Work Order ID 93859

Item Name: Crosstube Fwd High

DRAWING NO. D212-664-141	TITLE XTUBE ASSY (205/212/412 HI FWD)	REV. D	DART AEROSPACE LTD ENGINEERING ORDER		D.E.O. NO. D212-664-141-D-1	SHEET NO. SHEET 1 OF 2	SCALE NTS
DRAWN	CHECKED <i>CP</i>	MFG. APPR. <i>ER</i>	APPROVED <i>MP</i>	DE APPR. <i>MP</i>			
DATE 11.04.07	DATE 11.07.11	DATE 11.04.12	DATE 11/04/12	DATE 11.04.12

**D212-664-141/-141B
ASSEMBLY DETAIL**

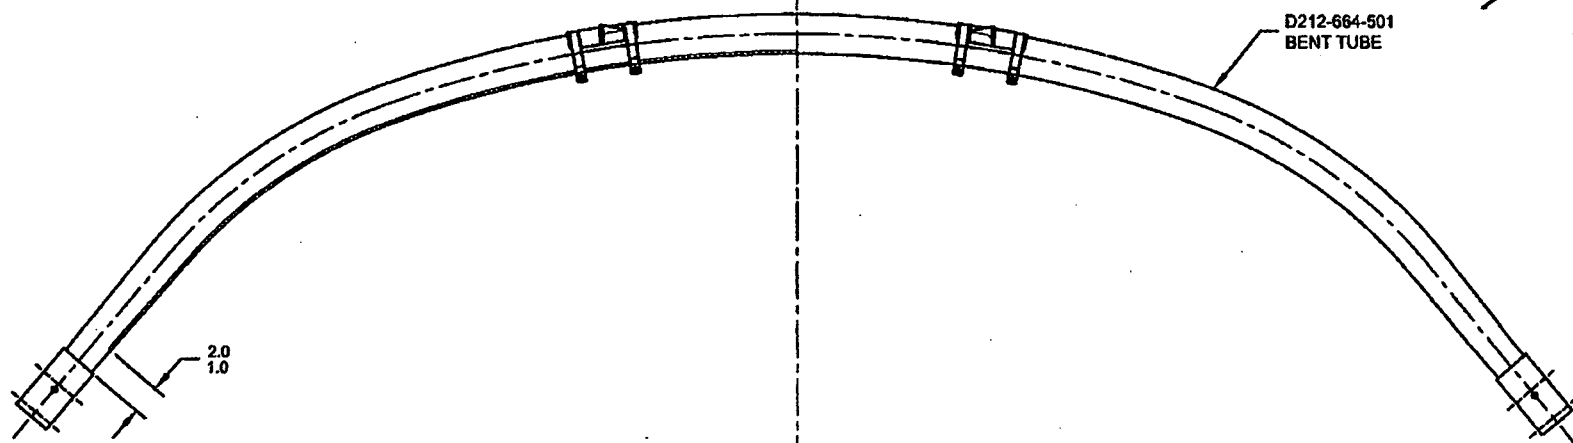
ADD AN INSPECTION WINDOW TO UNDERSIDE OF CROSSTUBE.

NOTES 2 OF SHEET 1 IS AMENDED AS FOLLOWS:

- 2) FINISH: CHEMICAL CONVERSION COAT PER DART QSI 005 4.1
PRIME INSIDE AND OUTSIDE PER DART QSI 005 4.2
MASK UNDERSIDE OF CROSSTUBE AS SHOWN (HATCHED AREA) AND
PAINT OUTSIDE PER DART QSI 005 4.2
REMOVE MASKING AND APPLY CLEAR COAT

MASK AREA PRIOR TO PAINTING,
REMOVE MASKING AFTER PAINT
AND APPLY CLEAR COAT
